**RE: Nuvemco, LLC's Last Chance Mine, File No. M-2008-012  
Technical Revision No. 1**

## **Exhibit 1a – Modifications required during construction, October 15 & 22, 2013 and PE certification**

Last Chance Mine Permit No. M-2008-012  
Technical Revision #1 Dated May 31, 2012  
As modified during construction October 15 & 22, 2012  
Page 2

**FIGURE  
NO. 2**

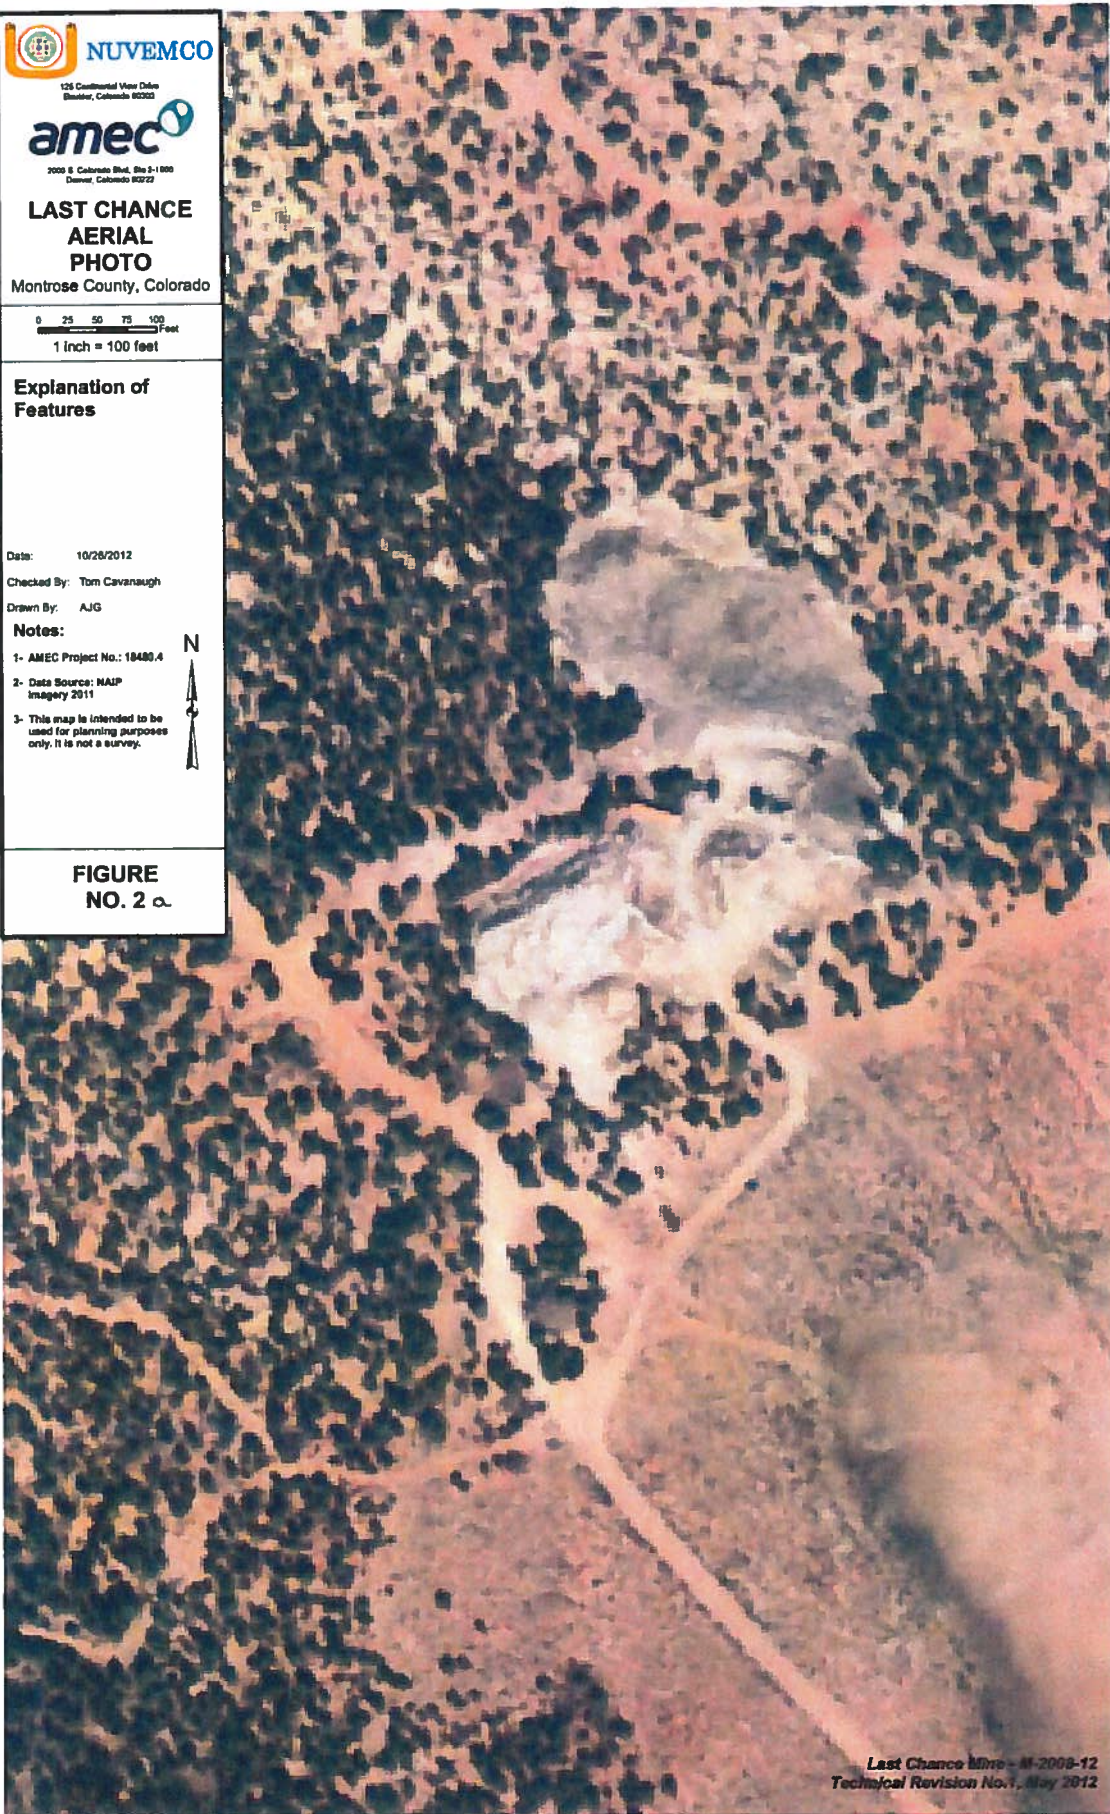
Figure No. 2a is aerial imagery from the NATIONAL AGRICULTURE IMAGERY PROGRAM (NAIP) from August 2011 which shows the current extent of the Waste Rock Area (WRA) and was utilized to locate the existing WRA. Figure 2b has the outlines of the three current drainage areas with respective locations of the receiving ponds. The locations and configurations of the ditches, berms and ponds which control stormwater runoff from the WRA will be determined and constructed in phases based upon mining activities. The Last Chance Mine is not currently being mined underground pending development drilling results and improved economic considerations. The WRA size and configuration is stable and smaller than the area used for calculations in the 2010 SWMP which provides latitude for alternative pond shapes to be constructed if they have equivalent volume. Nuvmeco will revise the SWMP utilizing different sized, but volumetrically adequate detention ponds for sediment control. This modification will maximize the effectiveness of natural features. Figure No. 1a is a modification that shows the location of each ponds. The northern temporary ore stockpile area as presented in the 2010 SWMP remains the same, as do the other inputs and calculations of the plan. The north and west parts of the Last Chance Permit have significant area to expand detention ponds for properly authorized expansion of mining operations in the future.

**FIGURE  
NO. 2 b**

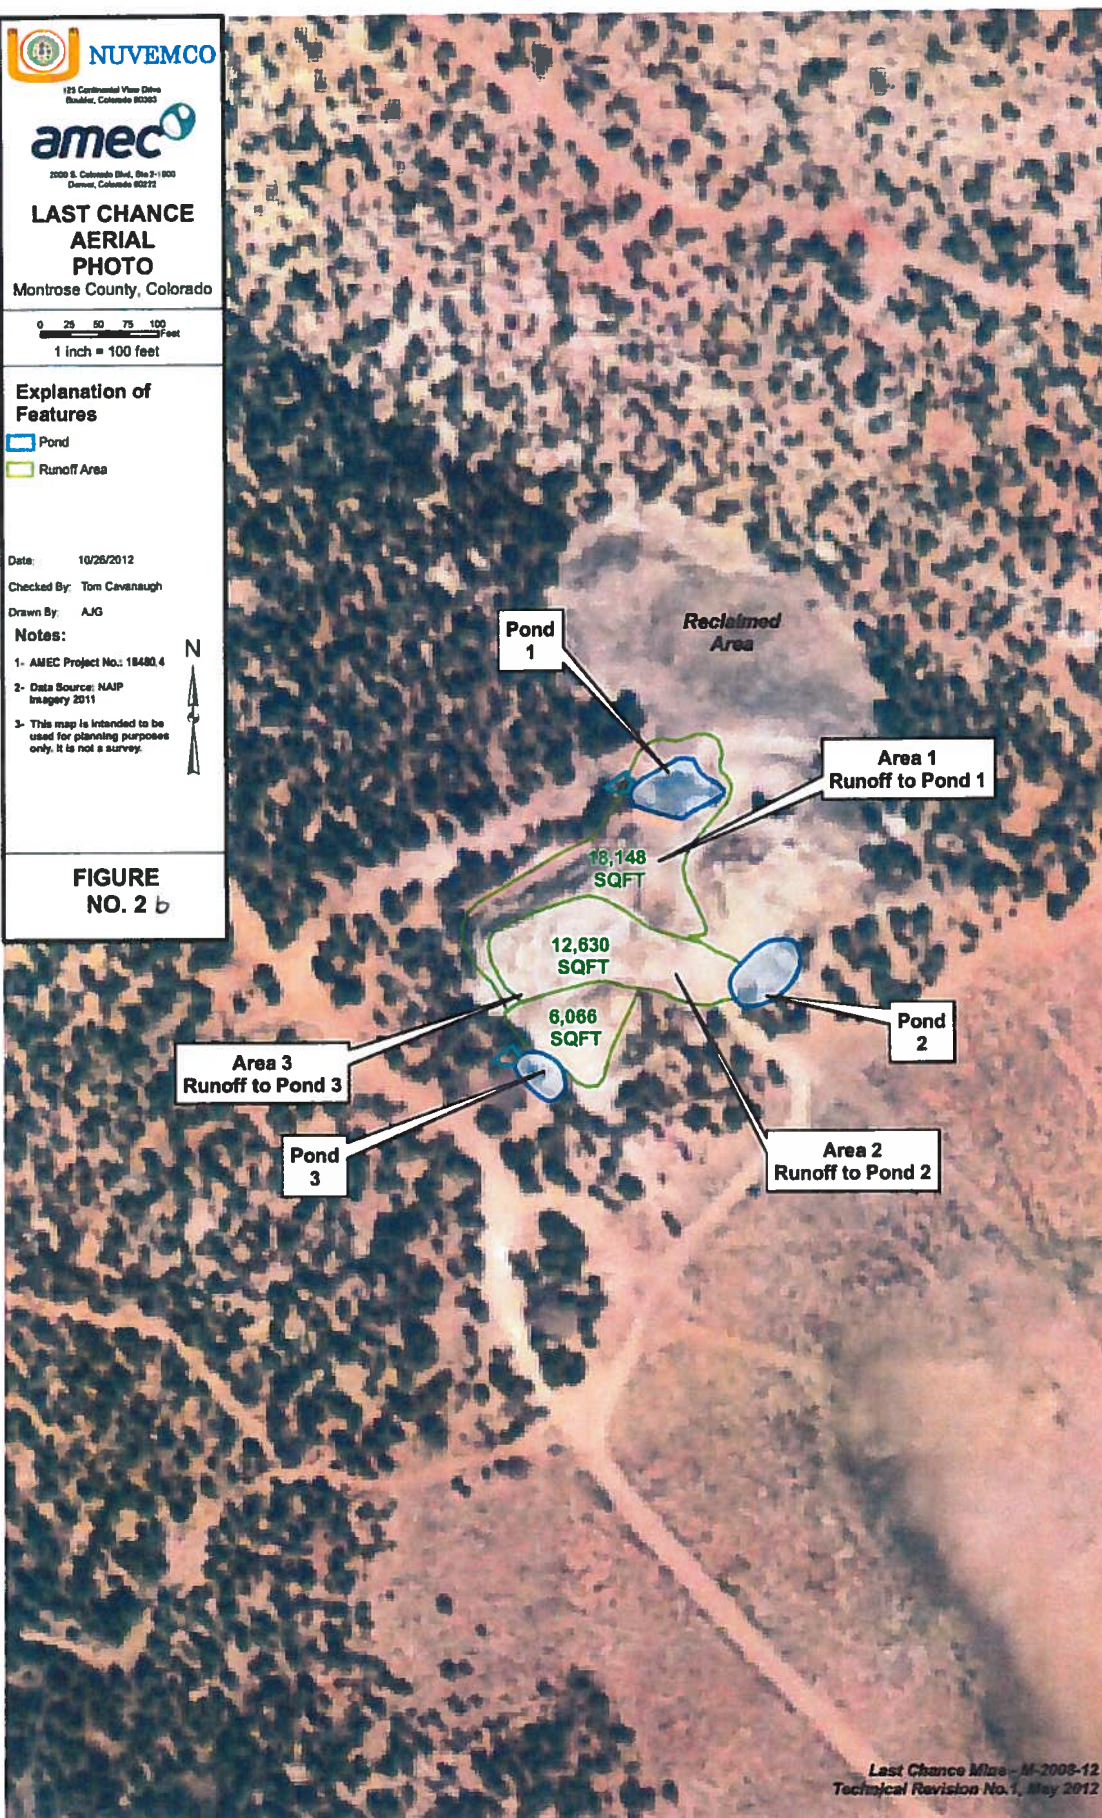
Modifications of the SWMP include managing the southwestern runoff from the Area 3 of the WRA to Pond 3, and the northern runoff by Pond No. 1 with their respective berms and ditches. The berms prevent run-on from the undisturbed areas and the ditches direct WRA runoff to the respective ponds. These detention ponds were be constructed to control runoff from precipitation falling on the WRA and other disturbed ground, minimizing additional disturbance until mining resumes. As shown corresponding to Phase 1, the current area drained to the detention ponds is 36,844 sq ft. Areas draining to specific ponds include: Pond No. 1 is 18,148 sq ft; 12,630 sq ft to Pond No. 2; and the remaining 6,066 sq ft is drained to Pond 3. The Maximum Runoff Volume calculations on page 5 of the SWMP were modified accordingly.
